FIFTH REPORT  
OF THE  
TMI-2 Technical Assistance and Advisory Group (TAAG)

April 1, 1983

This report covers the TAAG activities during the period of time from December 1, 1982, to April 1, 1983. In a letter, dated February 9, 1983, Mr. B. K. Kanga, Director, TMI-2, requested that TAAG address the following technical matters:

CALCULATED HEAD DOSE RATES  
CONTAMINATION ON SUPPORT TUBE ONLY

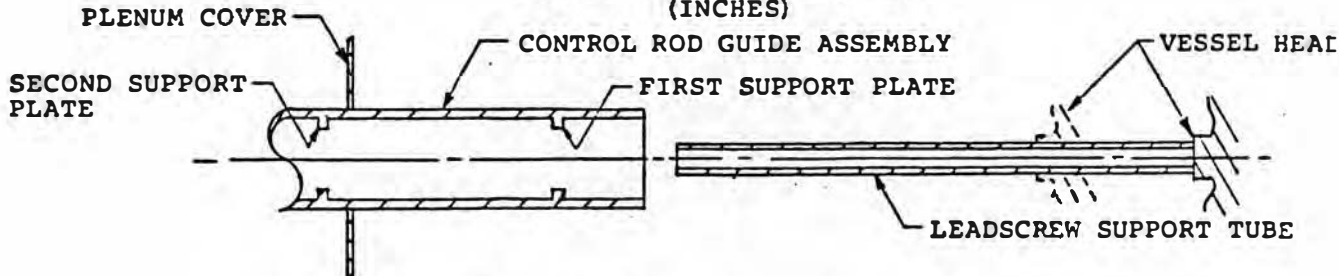
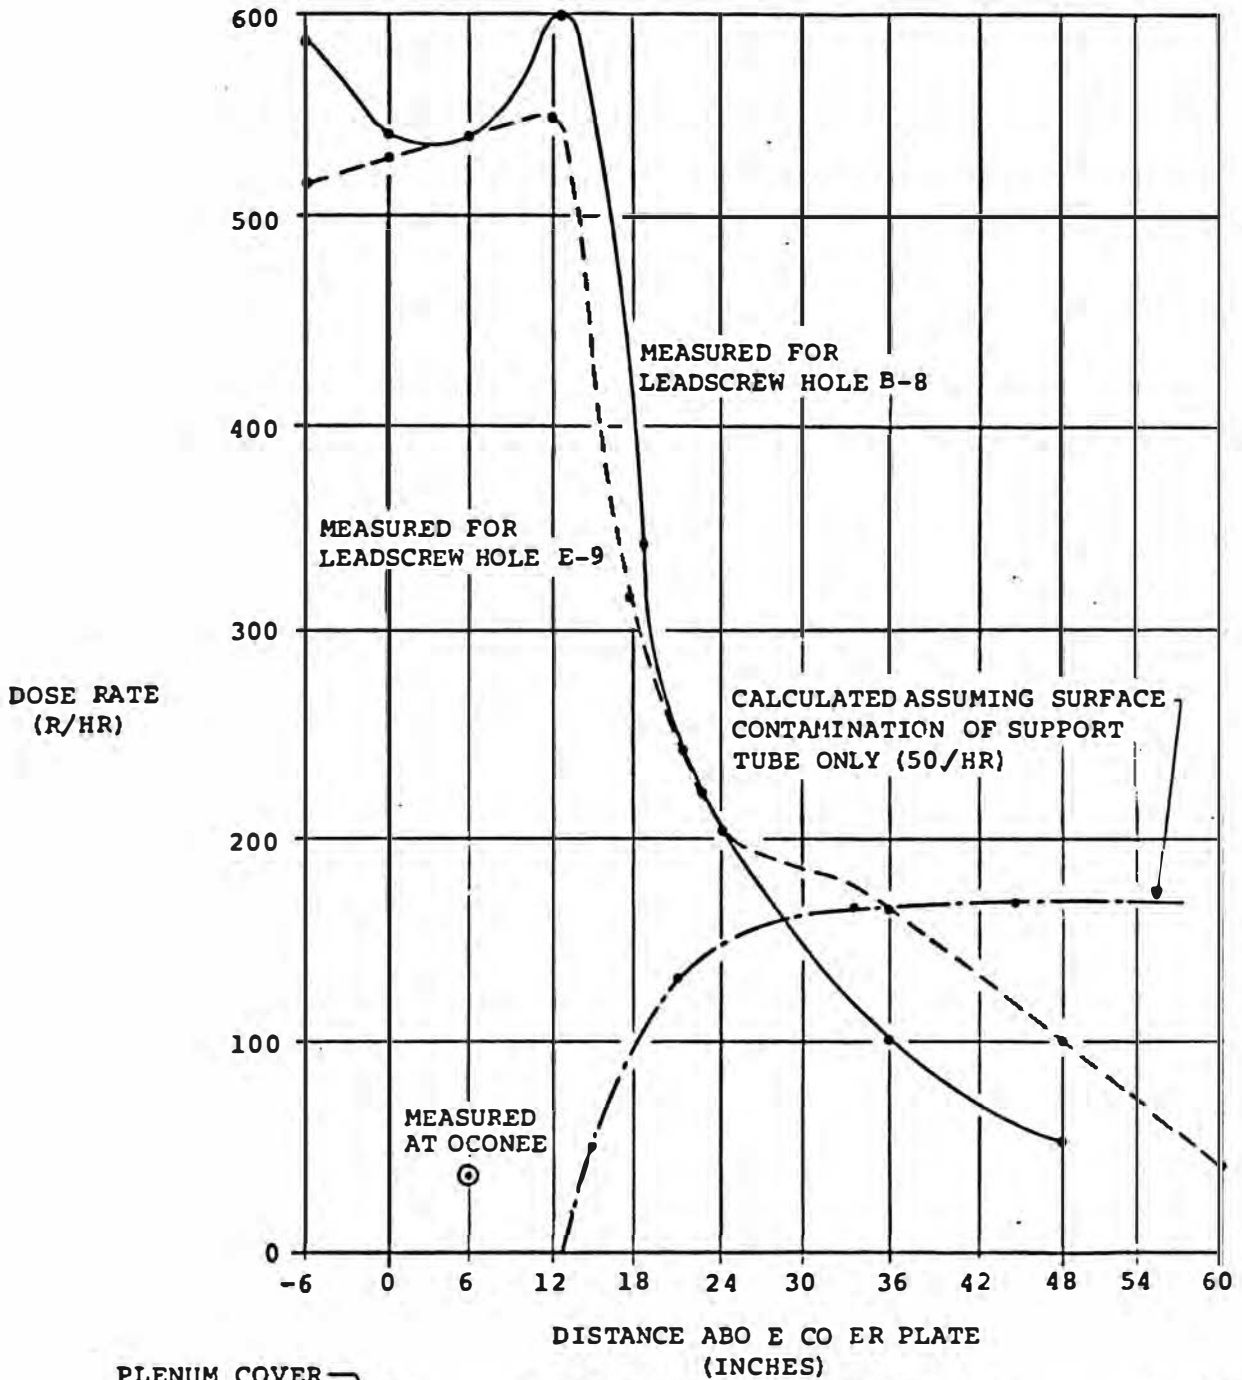
- The measured dose rates are consistent with having surface contamination on the leadscrew support tubes only, of about the same magnitude as on the removed leadscrew pieces (about 50 r/hr). This is shown in Figure 6, which compares the measured dose rates to those predicted for uniform contamination on the inside and outside surface of the support tube equal to that on the leadscrew. Actual dose rates are lower near the vessel head than would be predicted based on leadscrew contamination. One possibility is that the activity deposition is temperature dependent, so decreases near the head which was likely cooler than the support tubes.

In the second case, shown in Figure 6, it is assumed that surface contamination is present only on the inside and outside surfaces of the leadscrew support tubes. As shown, this results in a dose rate of about 160 r/hr from the head surface down to about six inches above the bottom end of the support tube. By comparison with the actual dose rates, the assumed amount of surface contamination is too high over the upper end of the support tube near the reactor vessel head.

The calculated dose shown in Figure 6 is lower than measured at the bottom end of the support tubes. However, this calculated dose does not include any contribution from plenum components. As shown later, if a plenum contribution is added to support tube contamination, calculated doses at the lower end of the support tube are about equal to the measured dose rates.

CALCULATED DOSE RATES  
AT LOCATION B-8 ASSUMING SURFACE CONTAMINATION

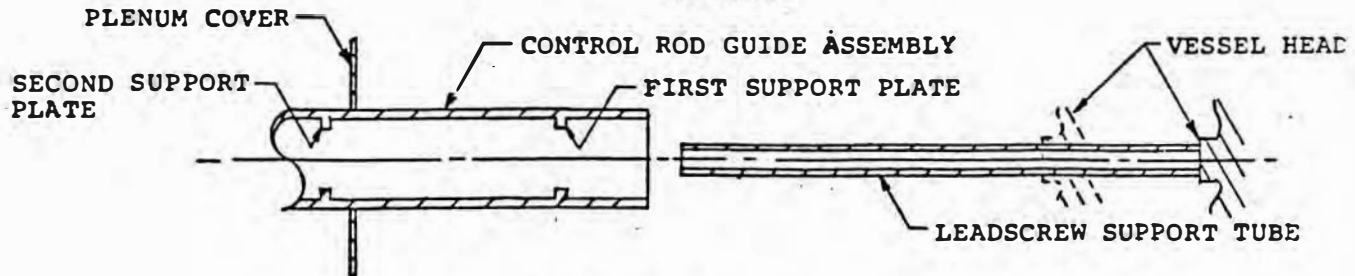
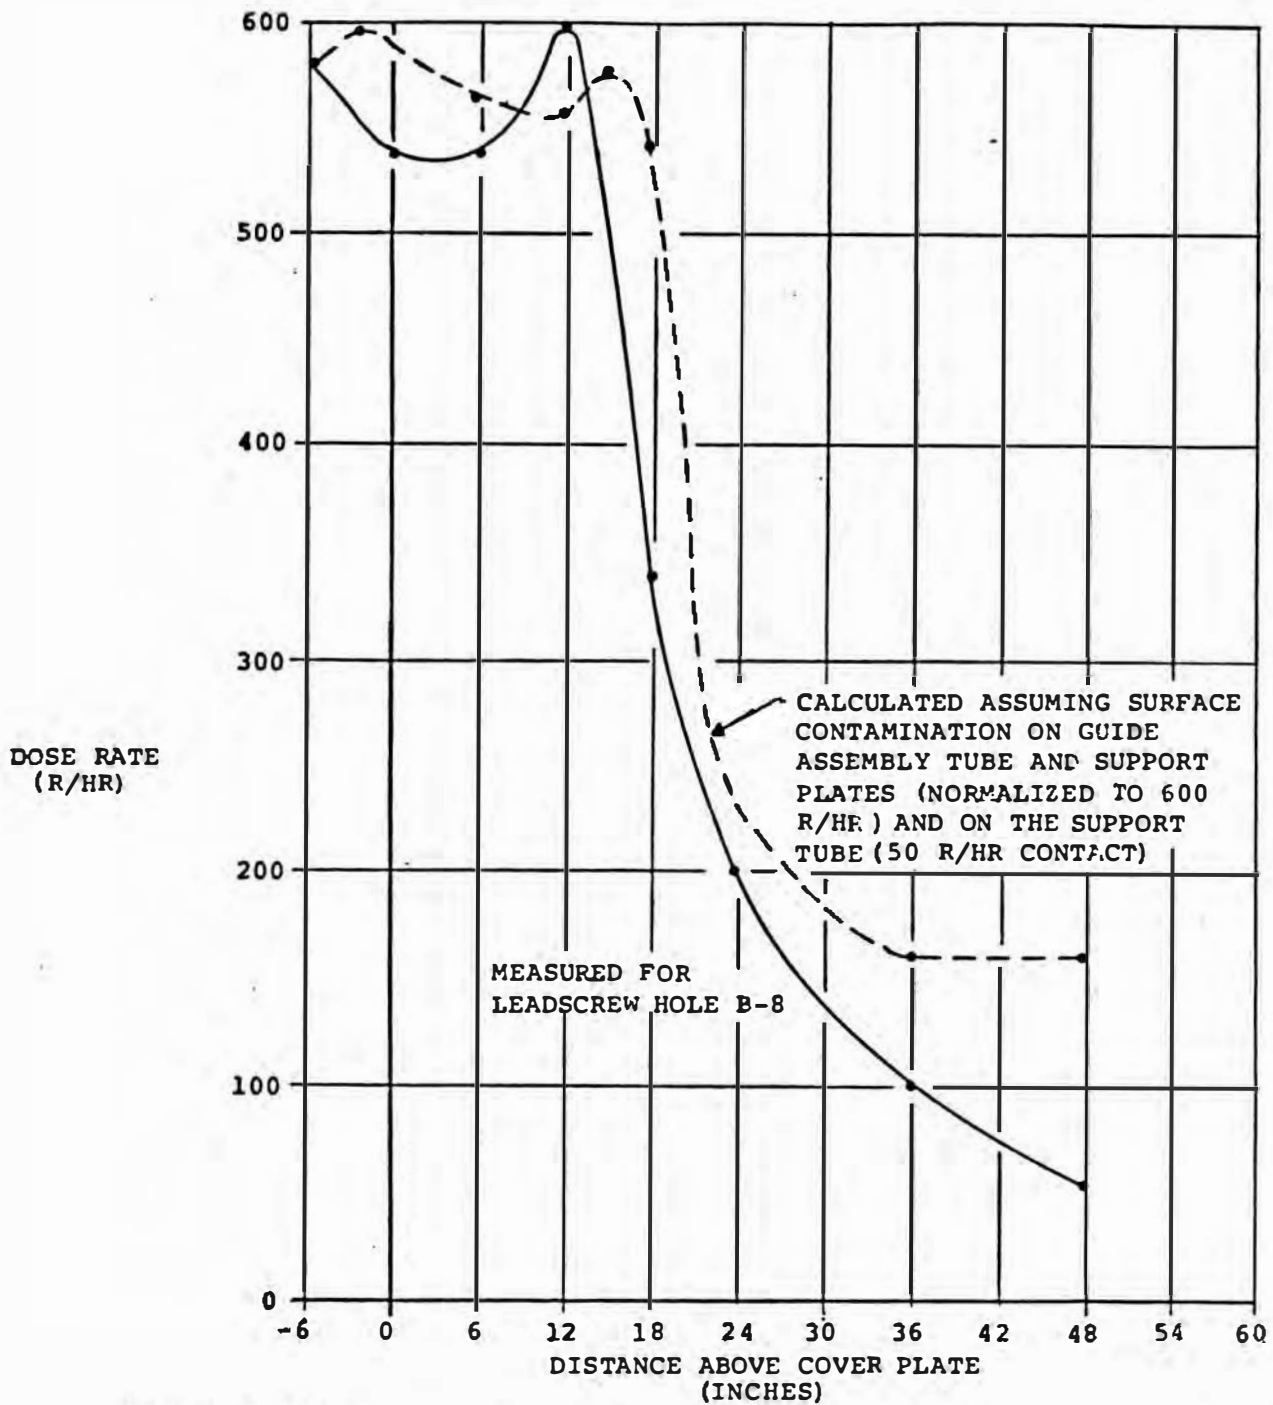
The combined dose rates; i.e. the dose rates from plenum components as calculated above and the dose rates from the leadscrew support tubes as calculated in Section 4.b, are shown in Figure 13 for position B-8. The calculated dose rates show fairly good agreement with the measured dose rates.
